## RESPONSE TO REQUEST FOR ADDITIONAL INFORMATION

### APR1400 Design Certification

Docket No. 52-046

RAI No.: 182-8160  
SRP Section: 03.07.01 – Seismic Design Parameters  
Application Section: 3.7.1  
Date of RAI Issue: 08/31/2015

Figure 19 Comparison of PSD between Full Duration and Truncated Duration for CSDRS-EW Compatible Time History

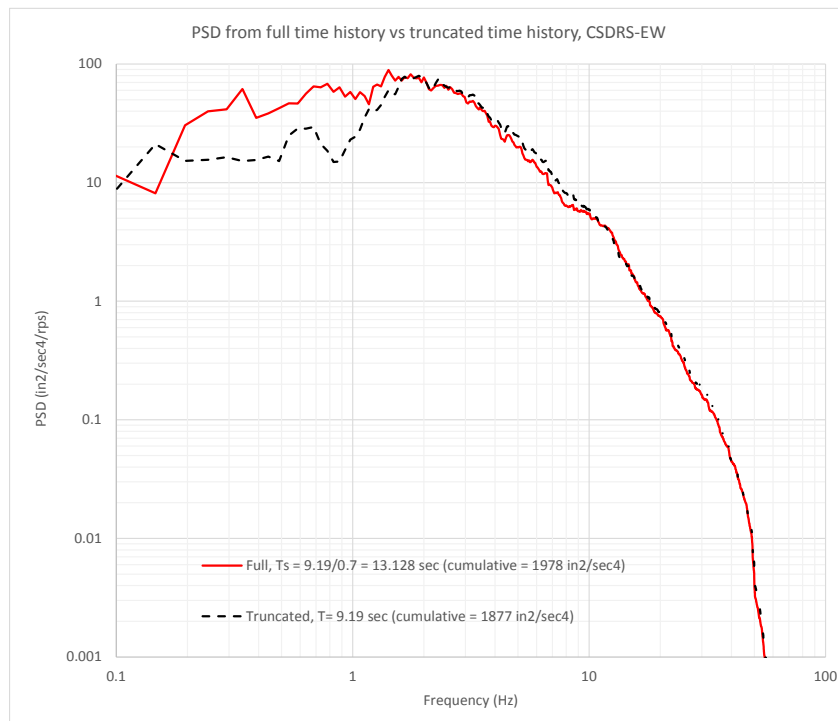
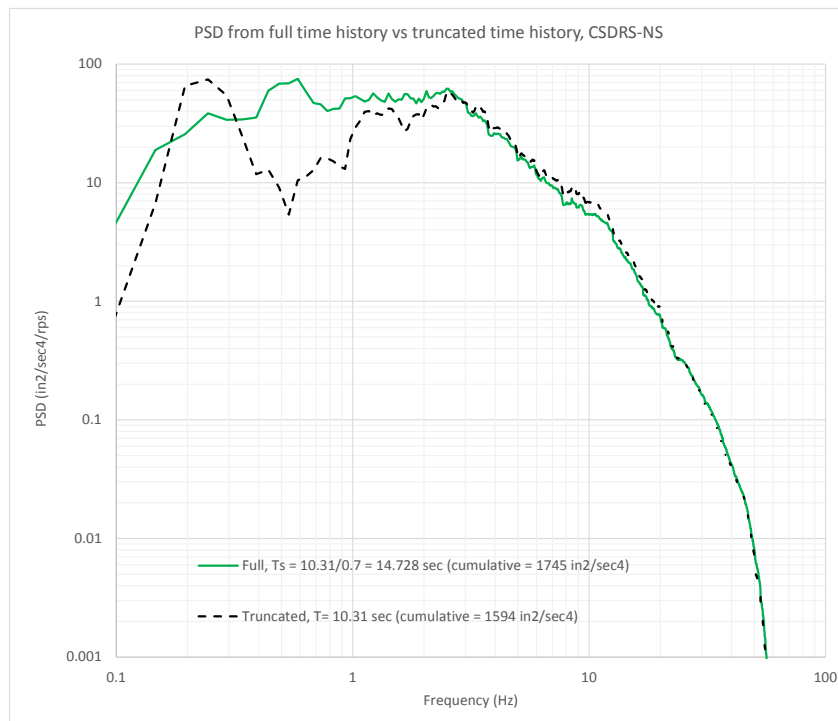
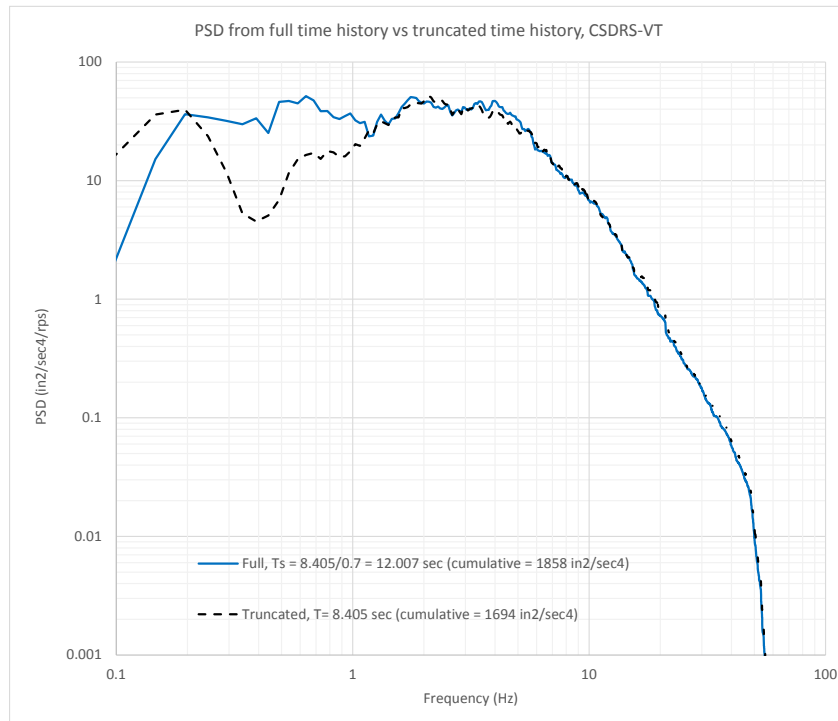
Appendices A and B of SRP 3.7.1 indicate that PSD should be estimated based on the strong motion duration. Therefore, the staff requests that the applicant provide a justification for the use of equivalent stationary strong-motion duration. Similarly, the applicant is requested to explain why the entire time histories were used in the Fourier transform. The use of the equivalent stationary strong-motion duration, which is shorter than the entire duration as shown in Figure 3-27 of APR1400-E-S-NR-14004-P, Rev. 1, together with the entire time history used in the Fourier transform, may overestimate the PSD for those frequencies that have very low magnitude but span the entire time history

The full time histories are the time histories of full duration from 0 to 20.48 seconds. The truncated time histories are the time histories truncated from the time  $T_{5\%}$  to the time  $T_{75\%}$  of the Arias Intensity plots. Using these definitions, the 5% to 75% truncated equivalent stationary duration designated as  $T_{(75\%-5\%)}$  is computed as  $T_{(75\%-5\%)} = T_{75\%} - T_{5\%}$ . Similarly, the 0% to 100% extended equivalent stationary duration designated as  $T_{(100\%-0\%)}$  is computed as  $T_{(100\%-0\%)} = T_{100\%} - T_{0\%} = (T_{75\%} - T_{5\%}) / (75\% - 5\%) = T_{(75\%-5\%)} / 0.7$ . The time histories, the Fourier amplitudes, PSD and smoothed PSD for time histories of full duration and truncated time histories are shown in Figures 1 through 18, respectively. The comparisons of PSDs for CSDRS compatible time histories between full duration and truncated duration are shown in Figures 19 through 21.

The results that the time-history PSDs computed using the full-duration time histories and the corresponding 0% to 100% extended equivalent stationary duration  $T_{(100\%-0\%)}$

are very consistent and comparable with the time-history PSDs computed from the 5% to 75% truncated time histories and the corresponding truncated 5% to 75% equivalent stationary duration  $T_{(75\%-5\%)}$  for the frequency range from about 2 to 50 Hz. These results validate the procedure of using the full-duration time histories and the corresponding 0% to 100% extended equivalent stationary duration  $T_{(100\%-0\%)} = T_{(75\%-5\%)/0.7}$  to compute the time-history PSDs, giving the resulting PSDs so computed being very equivalent and comparable to the time-history PSDs computed using the 5% to 75% truncated time histories and the corresponding truncated 5% to 75% equivalent stationary duration  $T_{(75\%-5\%)}$  for the frequency range from 2 to 50 Hz.

For the lower frequency range below about 2 Hz, i.e., for the low frequency range from 0.2 to 2 Hz, the time-history PSDs computed using the full-duration time histories and the 0% to 100% extended equivalent stationary duration  $T_{(100\%-0\%)} = T_{(75\%-5\%)/0.7}$  deviate from the time-history PSDs computed using the 5% to 75% truncated time histories and the corresponding 5% to 75% equivalent stationary duration  $T_{(75\%-5\%)}$  because the truncation of the full-duration time histories to a shorter-duration time histories affects the long-period (low-frequency) motion contents and amplitudes as indicated by the comparisons of the time-history response spectra for the full-duration and truncated time histories. The longer the truncated time-history duration the lower the validity frequency range of the computed truncated time-history PSDs. As shown in Figures 22 through 24, the response spectra of the truncated time histories fall below the corresponding full-duration time-history response spectra, which also fall below the corresponding target CSDRS in the low frequency range from 0.2 to 2 Hz as also indicated from the comparisons of the computed PSDs in the same low frequency range as shown in Figures 19 through 21.

From the results shown in above, it can be concluded that the use of full-duration time history and the corresponding 0% to 100% extended equivalent stationary duration  $T_{(100\%-0\%)} = T_{(75\%-5\%)/0.7}$  to compute the time-history PSD is a convenient and valid procedure to generate the time-history PSDs and the results so obtained are valid for a wider frequency range from the low frequency of 0.2 Hz to the high frequency of 50 Hz.

Figure 25 Cumulative Energy (Arias Intensity) Time History for CSDRS-EW

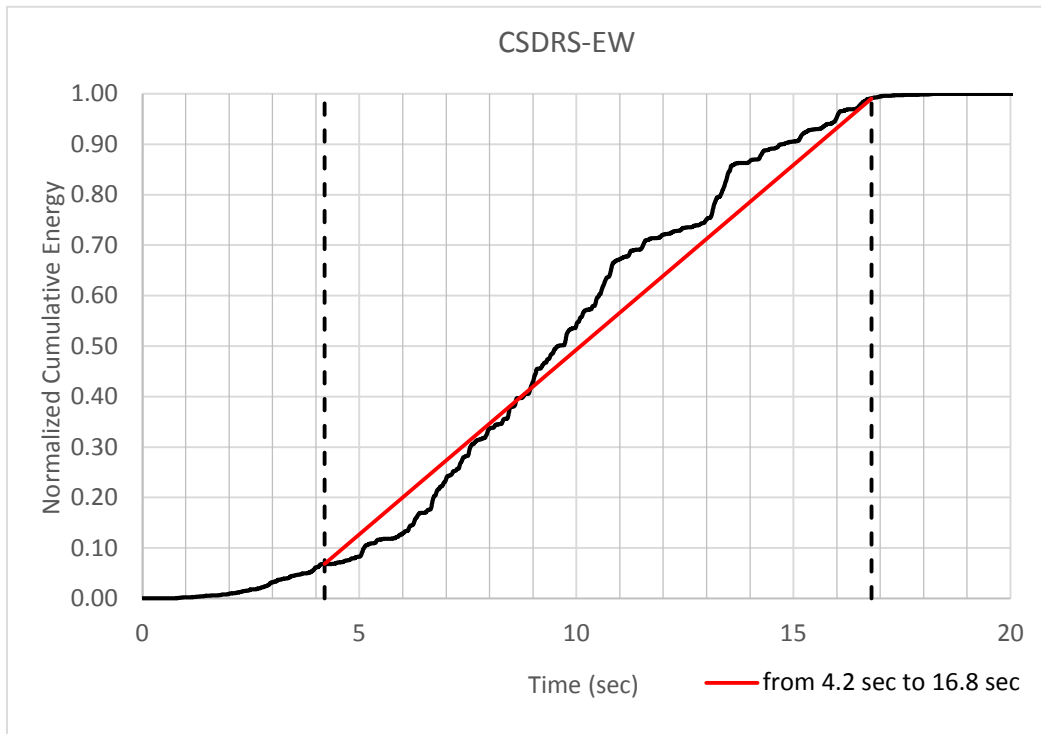
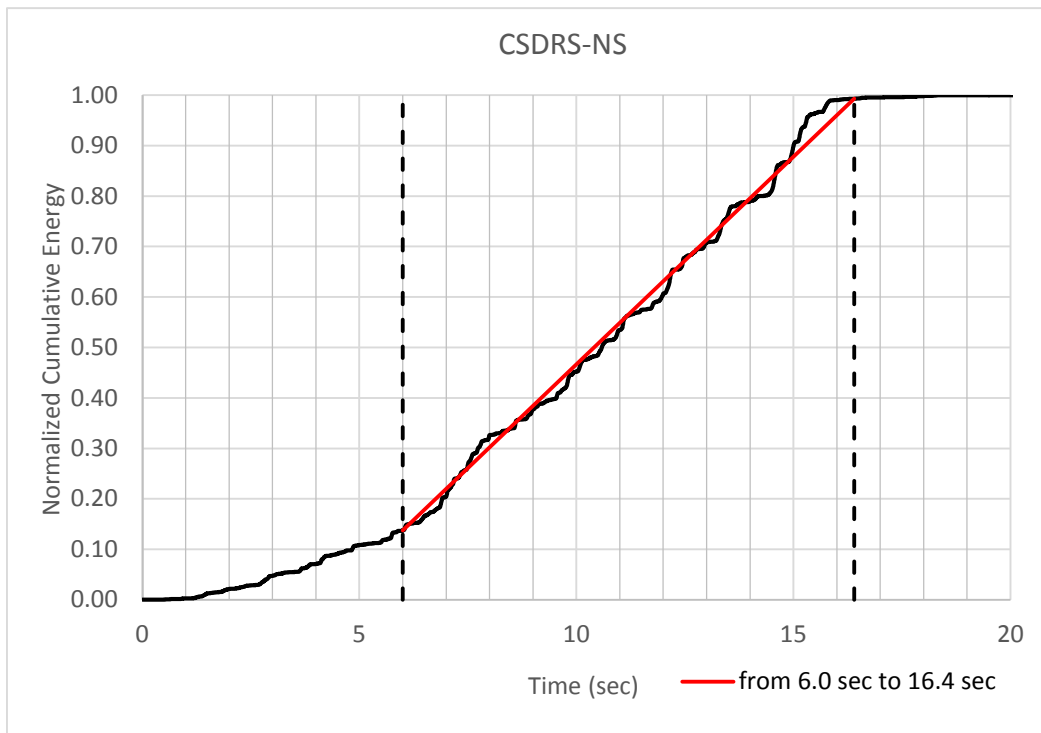
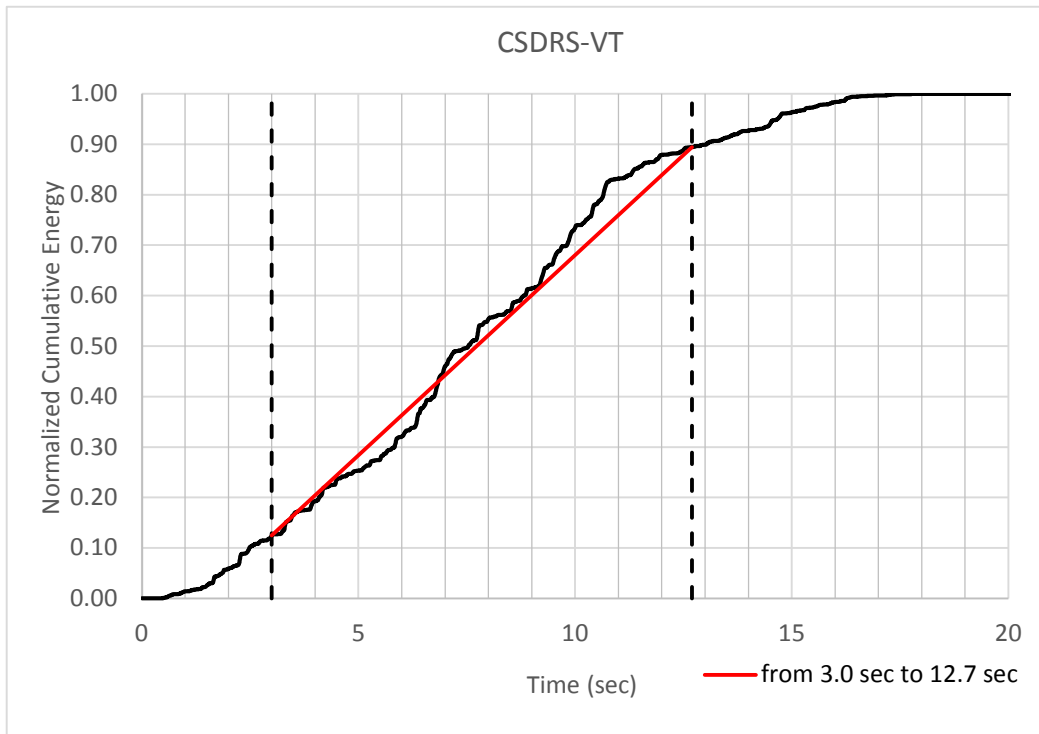
In DCD Section 3.7.1.1.2, the PSDs of the design acceleration time histories are compared to the corresponding target PSD. However, the method to estimate the PSD from an acceleration time history is not provided. Therefore, the applicant is requested to provide a description of the method for the PSD estimation and justify any difference of the method as compared to the guidance provided in SRP 3.7.1. The provided information should include the definition of the strong motion duration, portion of the time history used to compute the Fourier spectra, PSD smoothing, and any normalization parameters used in Fourier transform and PSD calculation.

Additionally, the PSDs for the CSDRS compatible time histories are computed in accordance with Appendix B of SRP 3.7.1, Rev. 4. The strong motion durations for the CSDRS compatible time histories are defined as shown in Figures 25 through 27. Using the truncated time histories and the corresponding the strong motion duration, the PSDs for the CSDRS compatible time histories are computed as shown in Figures 28 through 36. The PSDs for the CSDRS compatible time histories envelop 70% of target PSD as shown in Figures 30, 33, and 36. Therefore the PSDs for the CSDRS compatible time histories satisfy the requirement of Appendix B of SRP 3.7.1, Rev. 4.

Figure 37 Cumulative Energy (Arias Intensity) Time History for HRHF-EW

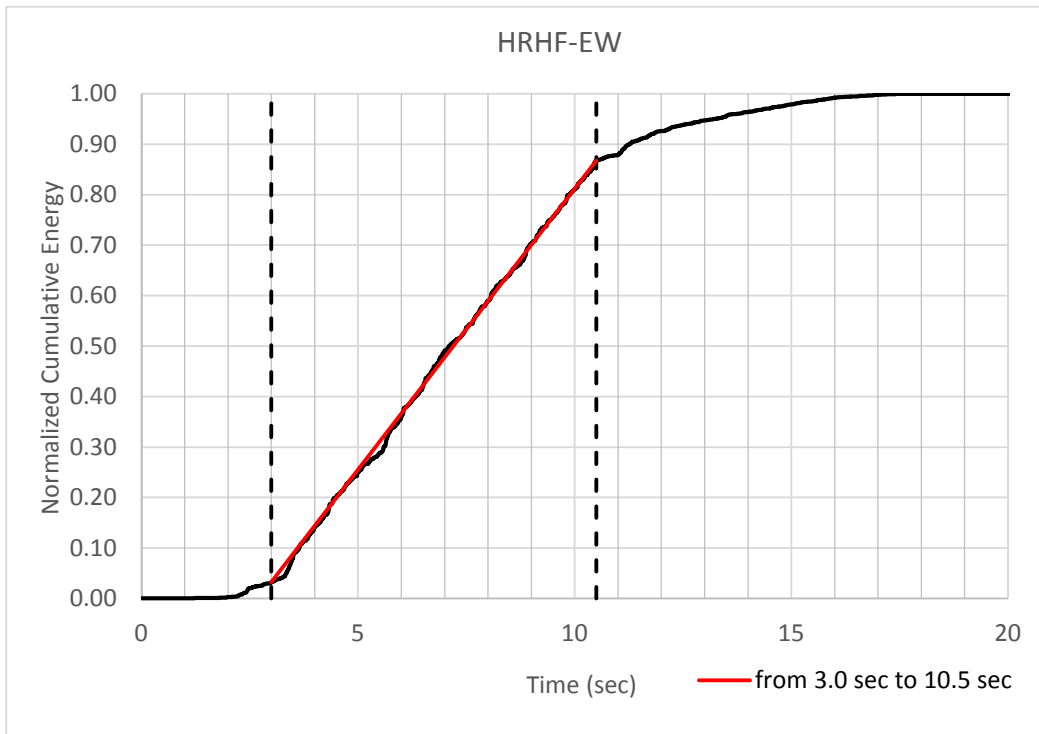
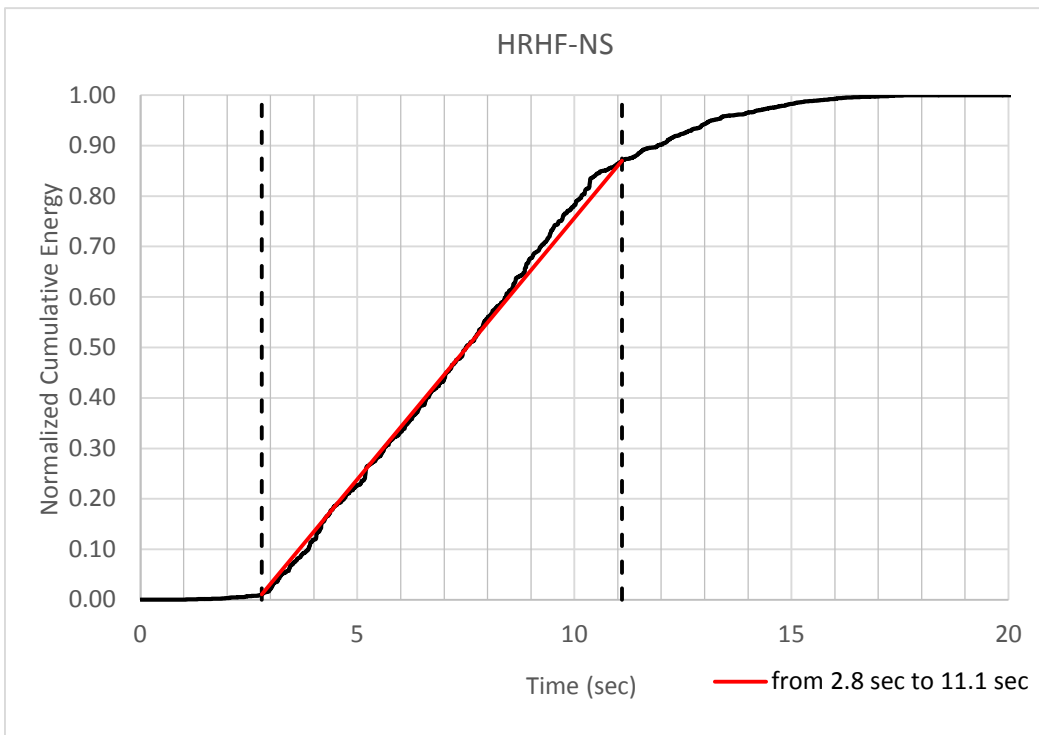
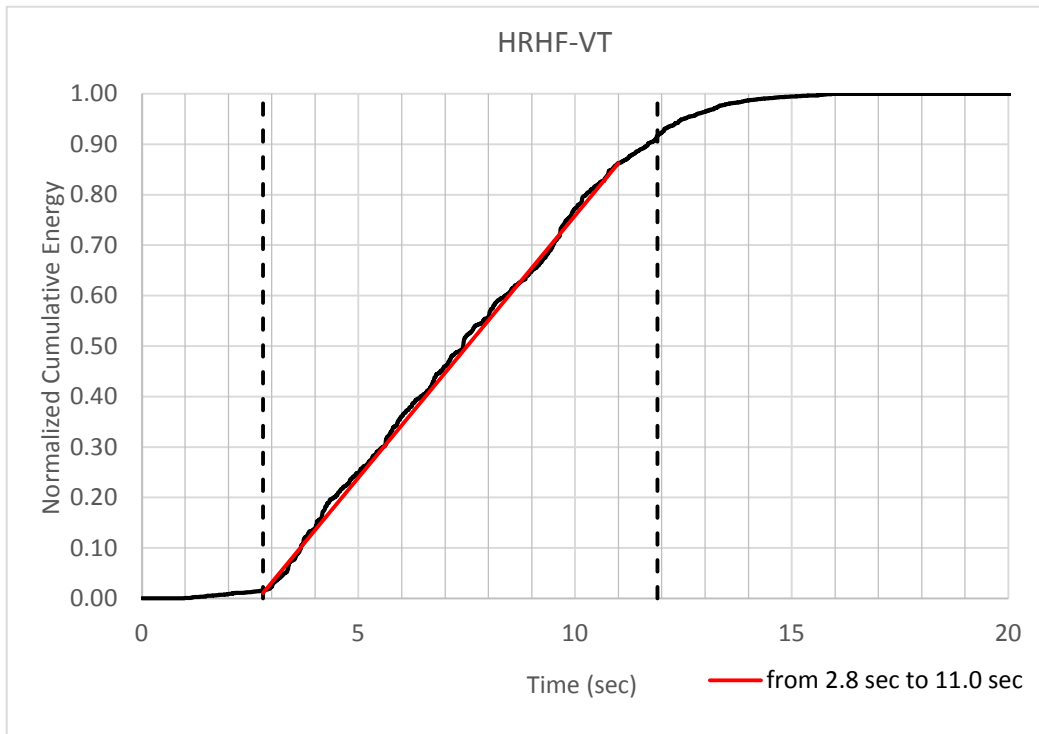
Section 3.5.3 of APR1400-E-S-NR-14004-P, Rev. 1, "Evaluation of Effects of HRHF Response Spectra on SSCs," describes the method used to calculate the PSD function from an acceleration time history. It utilizes an "equivalent stationary strong-motion duration" as the strong motion duration. The equivalent stationary strong motion is defined as the time for a P1-to-P2 rise of the cumulative Arias intensity, divided by (P2-P1). The applicant stated, "the equivalent stationary duration  $T_{is}$  for the entire time histories as determined from Eq. (3-3) is the duration over which the total energy of the time history is built up from 0 to 100 percent with the

constant slope S.” In this statement, the parameters P1, P2, and S are not defined. As such, the applicant is requested to provide these three parameters for the three HRHF acceleration time histories. In addition, it appears that the PSD estimate is very sensitive to the choice of P1 and P2; for example a P1=0 and P2=100% will lead to an equivalent stationary strong-motion duration  $T_s$  equal to the total duration of the time history. As such, the applicant is also requested to provide a justification for the values of P1 and P2.

The PSDs for the HRHF RS compatible time histories are computed using the procedure which is described in response to Question 03.07.01-3 (a) as shown in Figure 37 through 48. The PSDs for the HRHF RS compatible time histories satisfy requirement of Appendix B of SRP 3.7.1, Rev. 4 as shown in Figure 42, 45, and 48.
